ADDENDUM NO. 1

PROJECT NO: 1110169

TITLE OF PROJECT: Visitor Center Repairs and HQ Restroom Replacement

FACILITY LOCATION: Monahans Sandhills State Park

SHEET NUMBER
C-03

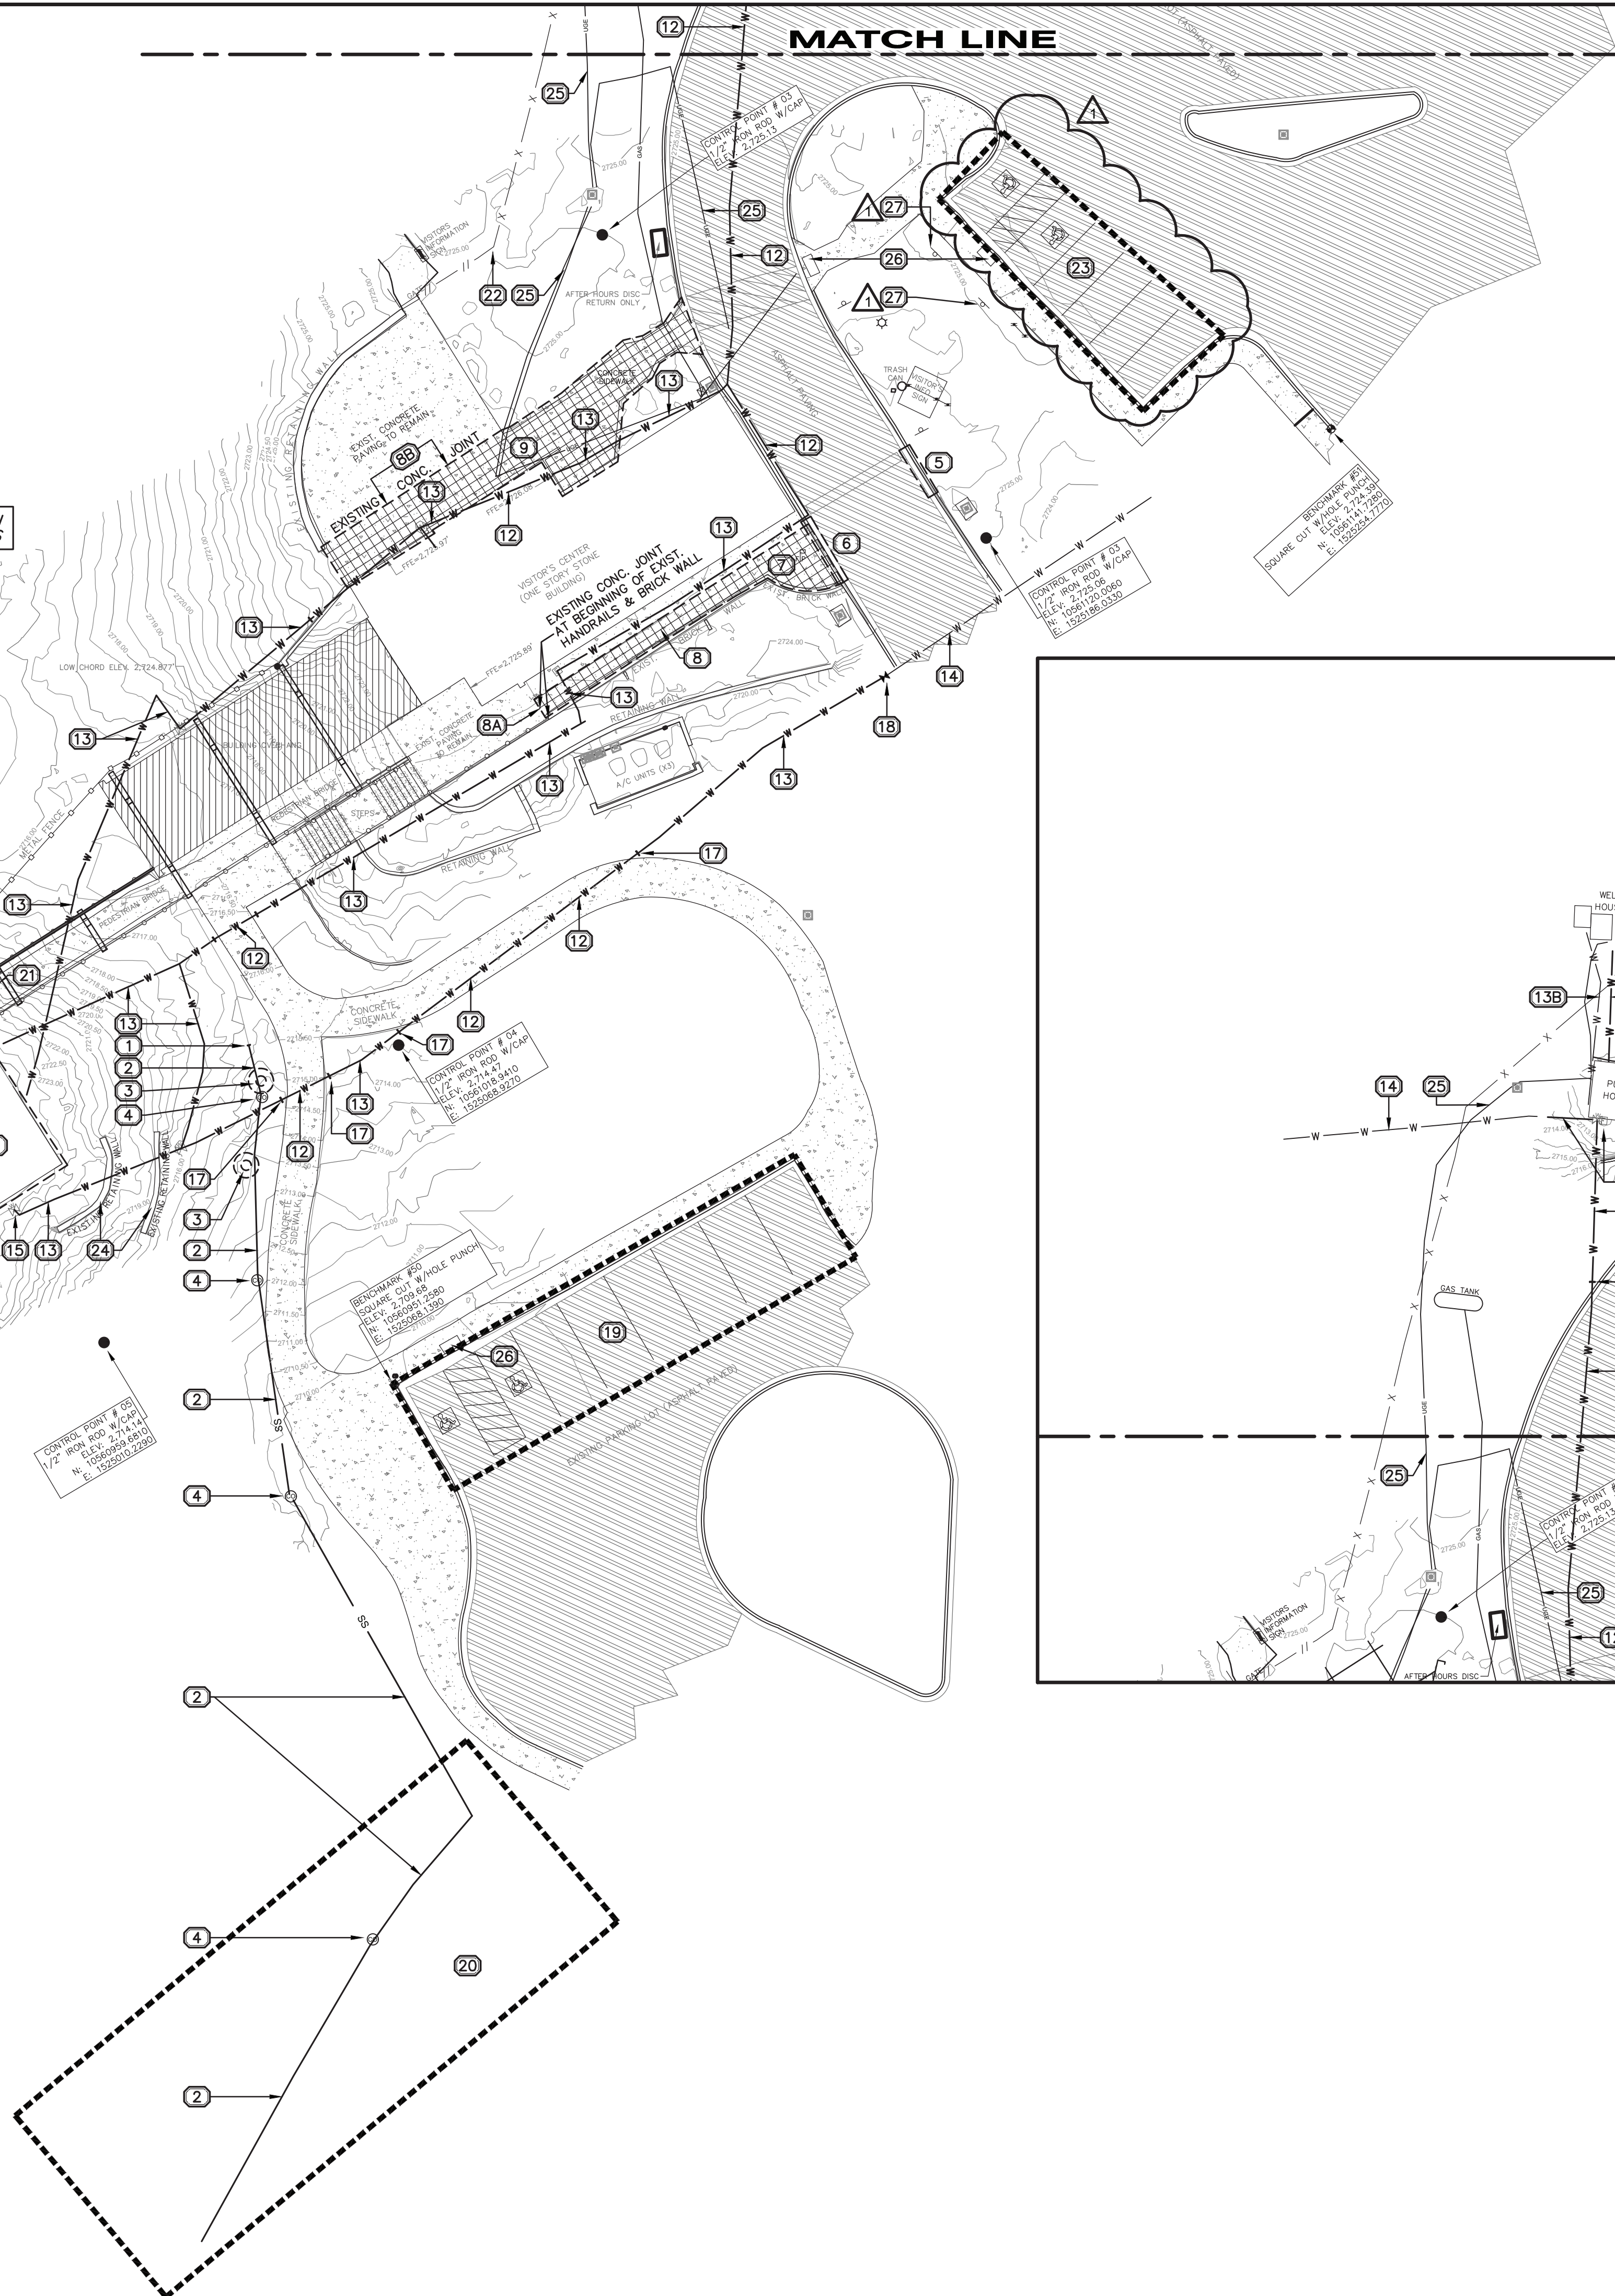
REVISED:
 ADD1 5/07/21
 PARKING SPACES STRIPING TO BE REMOVED.
 A.D.A. SIGNS TO BE REMOVED.

SHEET NUMBER
C-06

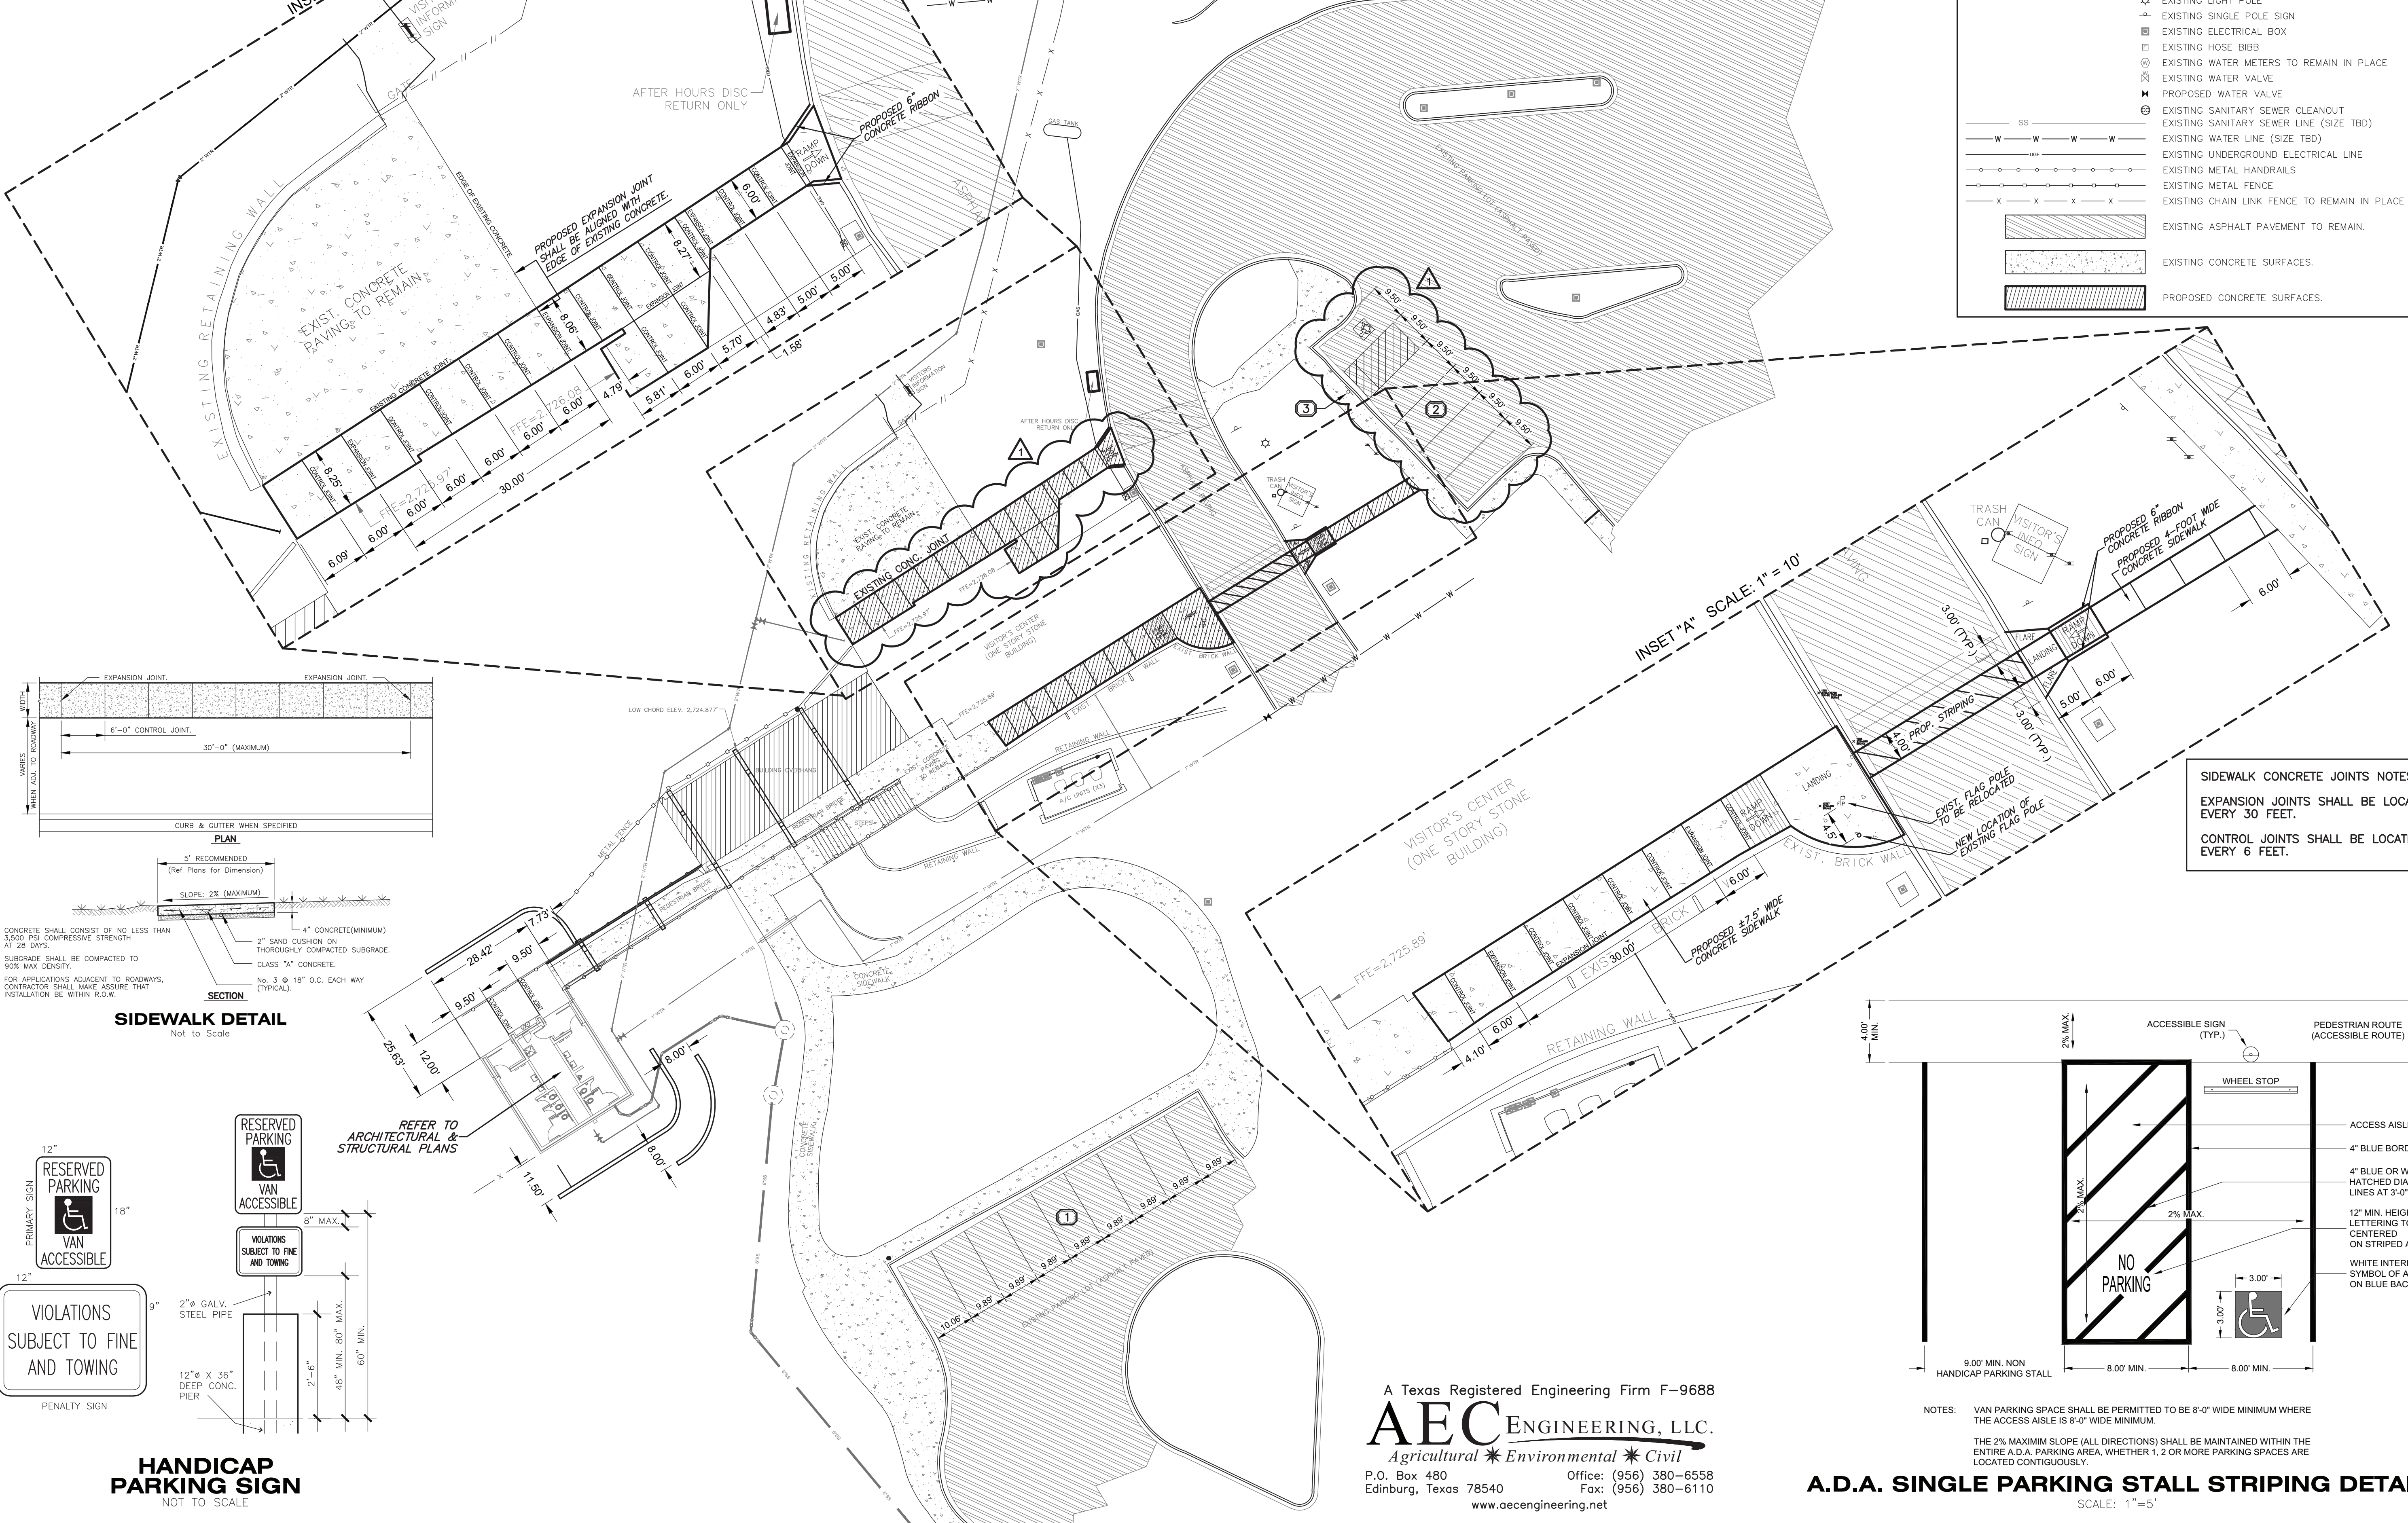
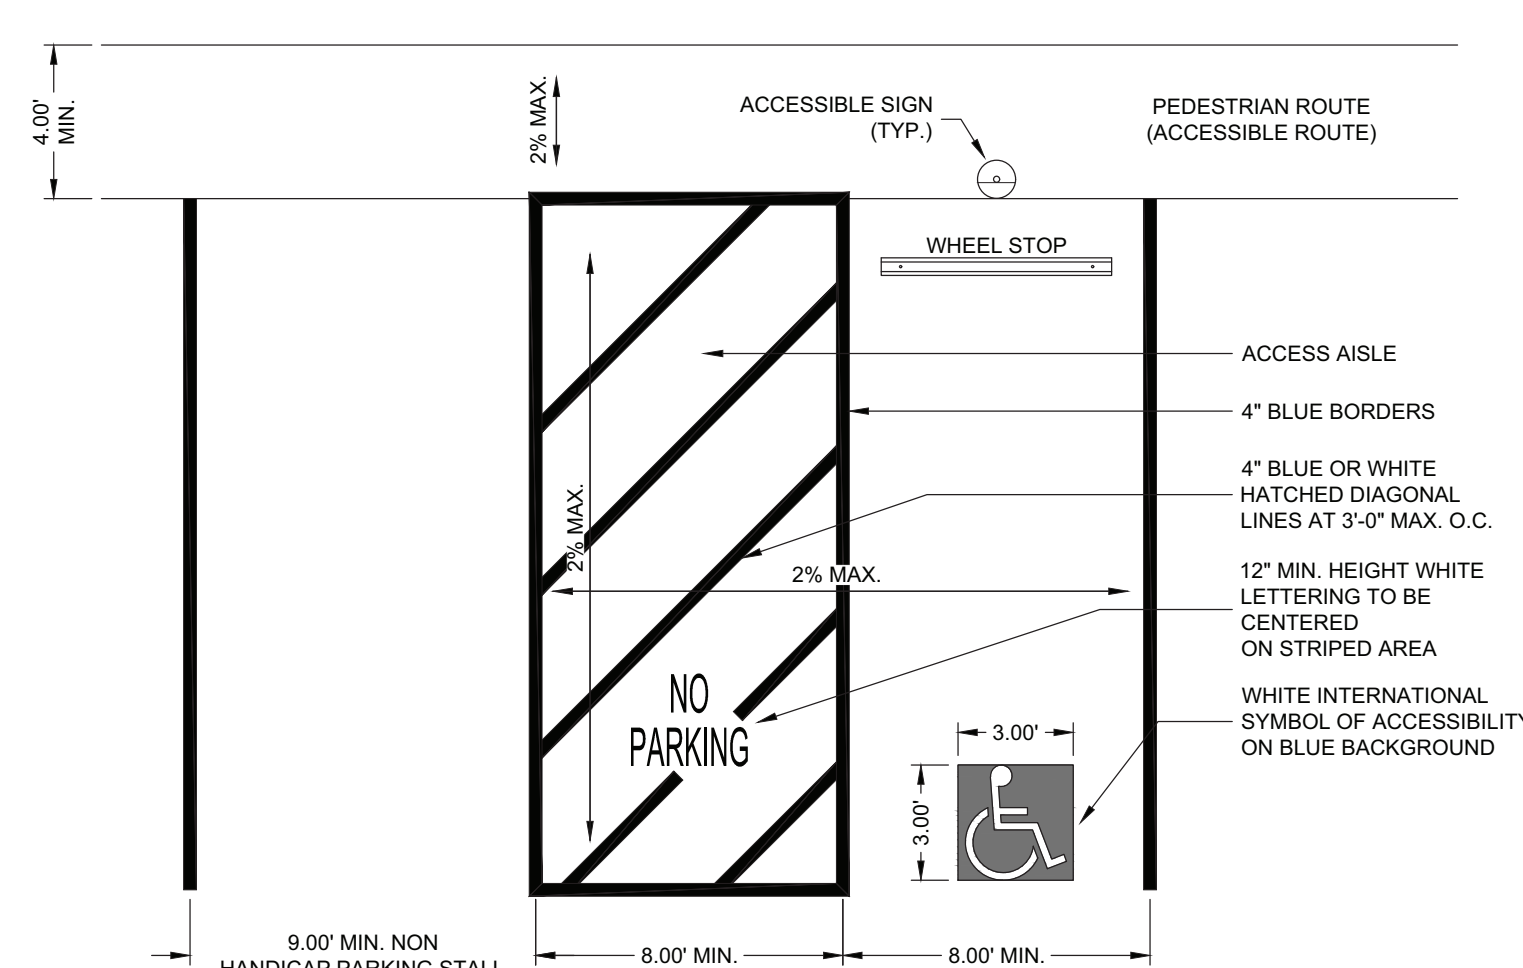
REVISED:
 ADD 1 5/07/21
 SIDEWALK WAS STRAIGHTENED, GRADES REVISED TO MEET A.D.A. REQ.

PARKING SPACES RE-ARRANGED, A.D.A. SIGN ADDED.
